LEXINGTON-FAYETTE URBAN COUNTY GOVERNMENT CONTRACT CHANGE ORDER Page 1 of 2	Date:	November 16, 2015	
	Project:	Senior Citizen Center Construction	
	Location:	Lexington	
To (Contractor): Marrillia Design & Construction 259 West Short Street Suite 325 Lexington, KY 40507	Contract No.	227-2014	
	Original Contract Amt.	\$8,882,900.00	
	Cumulative Amount of Previous Change Orders	\$1,349,994.37	
	Percent Change - Previous Change Orders		15.20%
	Total Contract Amount Prior to this Change Order	\$10,232,894.37	
	Change Order No.	28

PROJECT: Senior Citizen Center Construction

PROJECT	LFUCG Senior Citizens' Center 201333	DATE SENT	10/27/2015
SUBJECT	Entry Drive Subsurface Remediation	PROPOSAL REQUEST ID	PR-040
TYPE	Proposal Request	TRANSMITTAL ID	00713
PURPOSE	For Review and Response	VIA	Info Exchange

SHEET L6.1 R-1

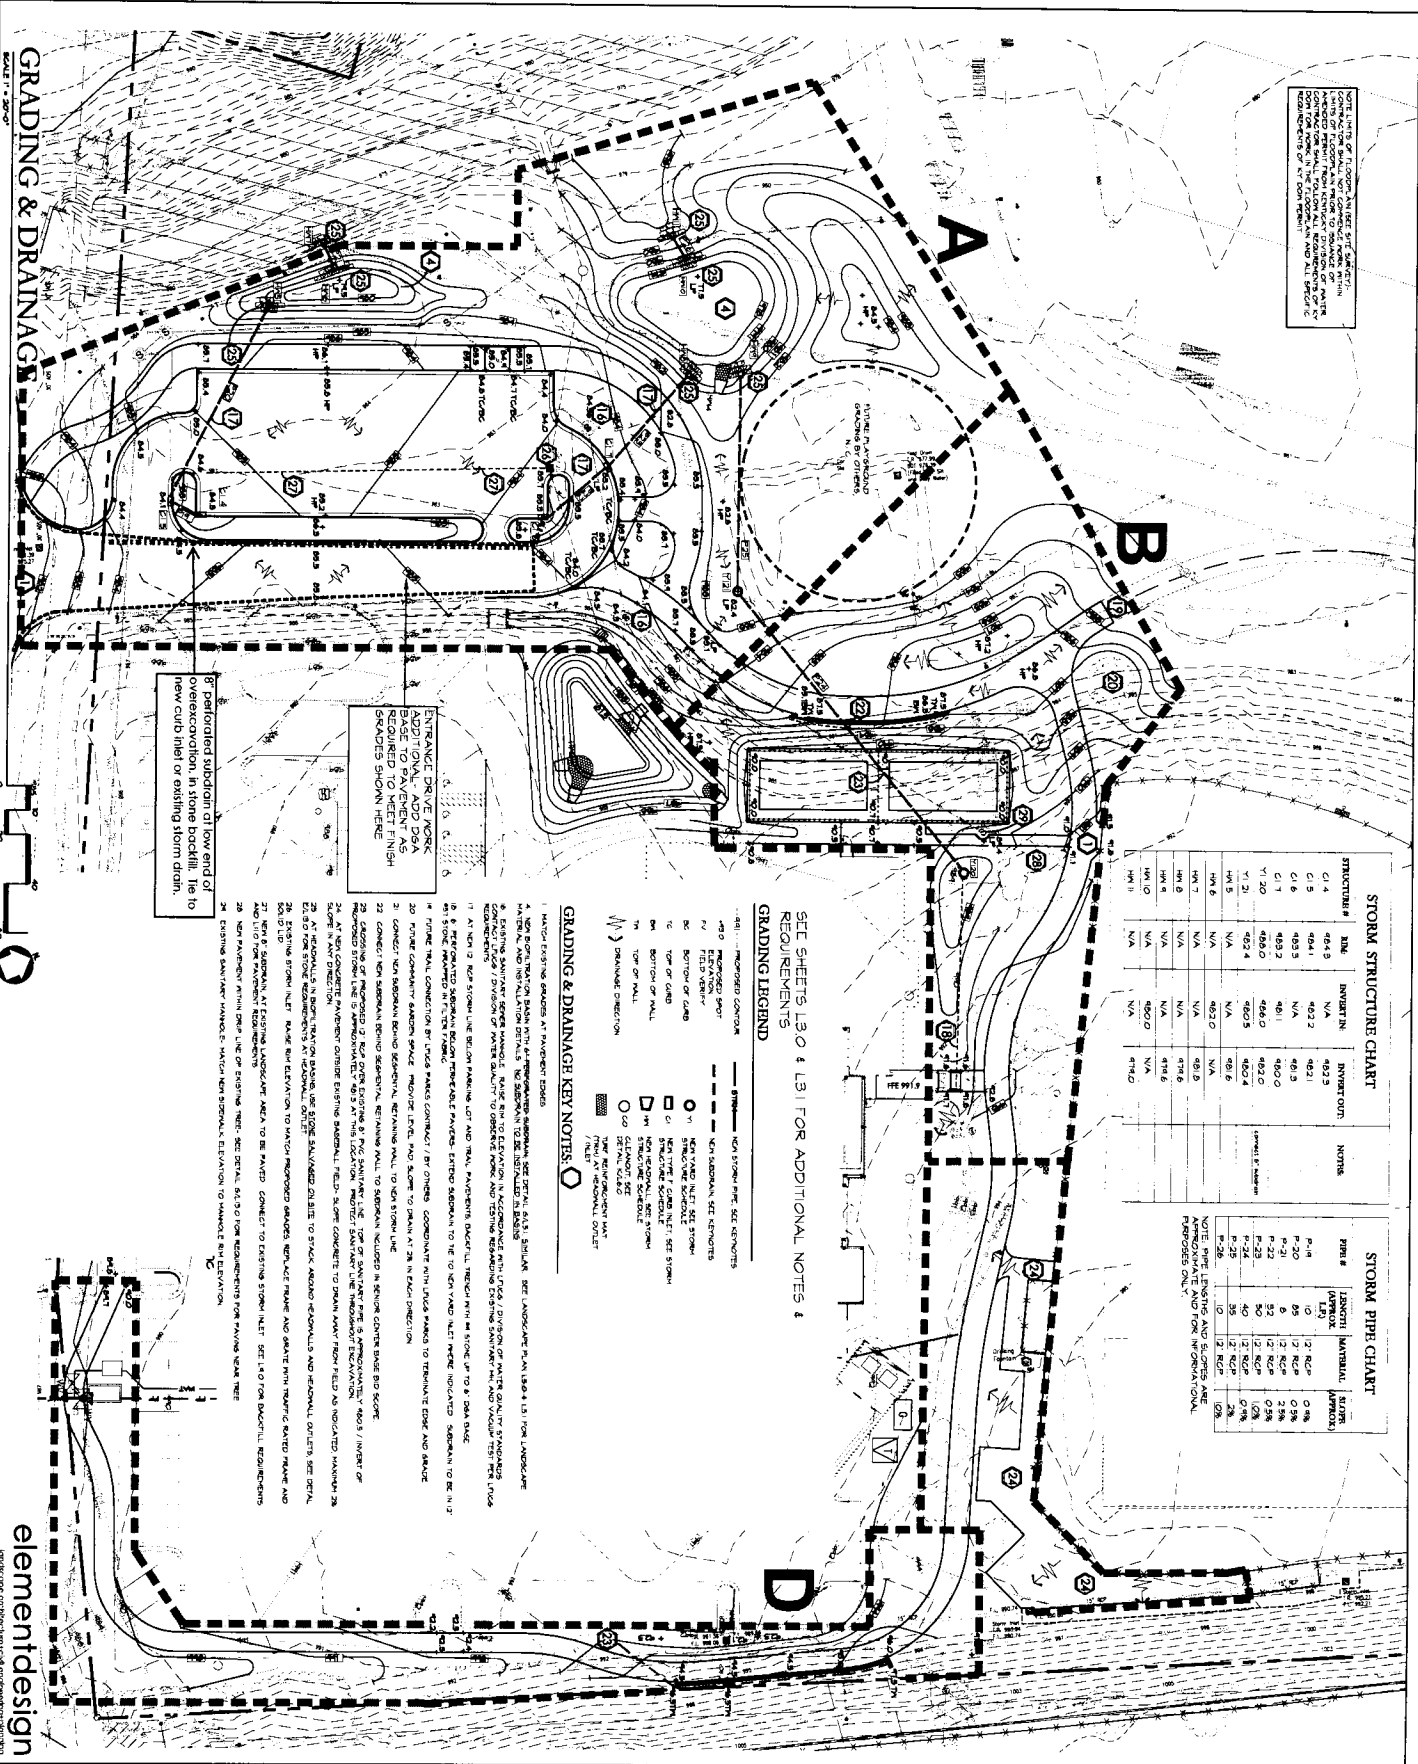
- undercut below pavement subgrade by 24 inches
- install an 8" perforated pipe at the base of undercut as shown on attached sketch L10.0, drain to structure CI-6
- install stone and geotextile per PR-018 recommendations (similar to those used in main parking areas, see attached sketch)

- install heavy duty asphalt paving (6" DGA, 5 1/2" base course, 1 1/2" surface course) over compacted sub-grade stone per A/L6.1

GEOTEXTILE, TENSAR BX1200 OR APPROVED EQUAL, CONTINUOUS BETWEEN #2'S AND #57'S

#2 STONE - PLACE IN SINGLE LIFT

MOVEN HIGH PERFORMANCE GEOSYNTHETIC FABRIC, MIRAFI HP570 OR APPROVED EQUAL, CONTINUOUS

SLOPE SUBGRADE 1/8" / FT MINIMUM TO 6" PERFORATED DRAIN TILE AND BEYOND

GRADING & DRAINAGE
SCALE: 1" = 20'-0"

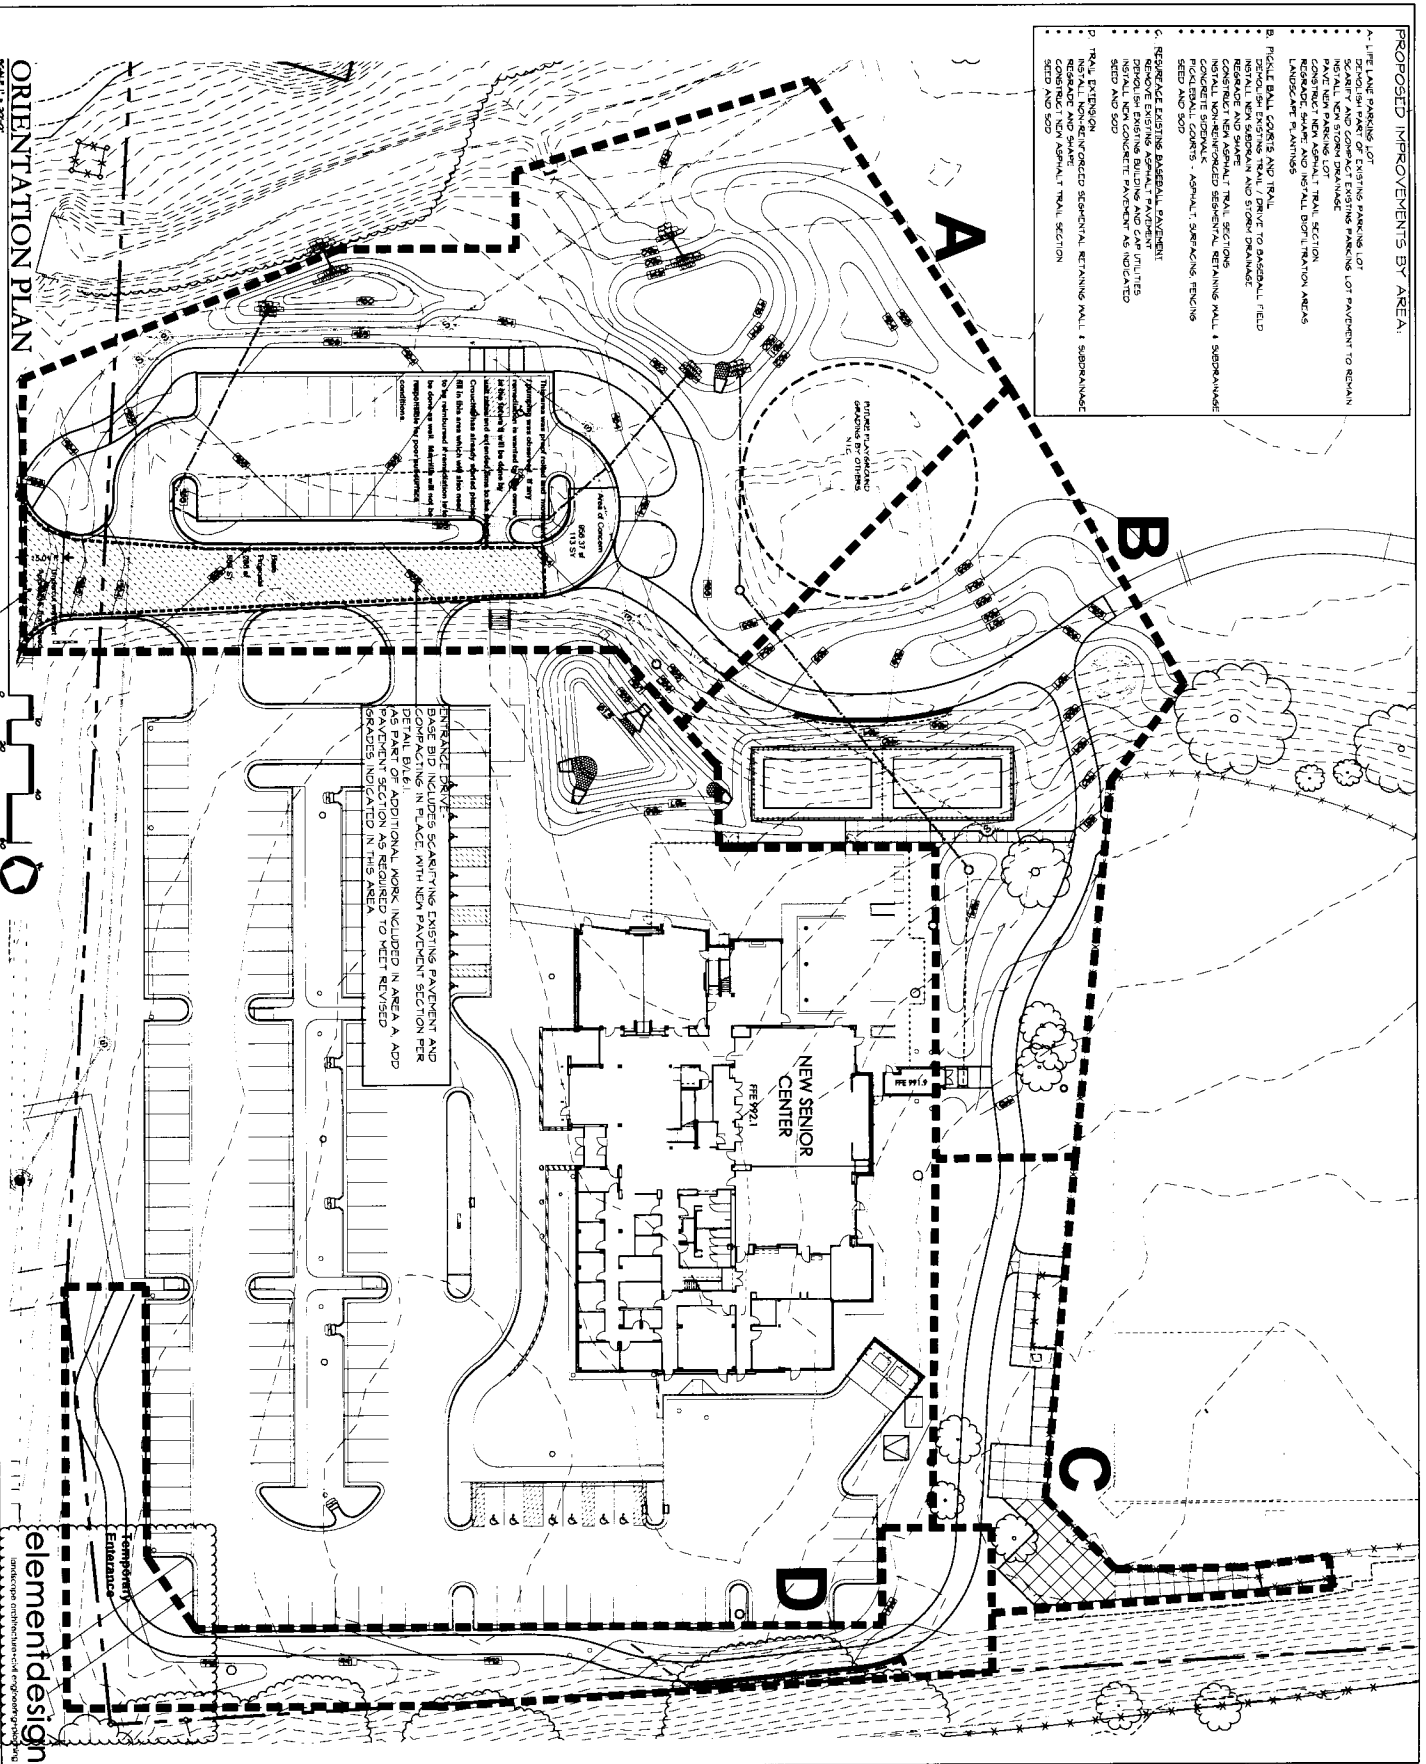
Please provide pricing to remediate the subsurface grades below paving subgrade at the Life Lane entry drive, per recommendations by the geotechnical engineer. Site observation has shown the entire entry drive area designated for heavy duty pavement (per sheet L4.1) is unstable under construction traffic, and the recommendation is as follows:

16' perforated subdrain at low end of overexcavation, in stone backfill. Tie to new curb inlet or existing storm drain.

ENTRANCE DRIVE WORK
ADDITIONAL ADD DATA
BASE TO PAVEMENT FINISH
GRADES SHOWN THERE
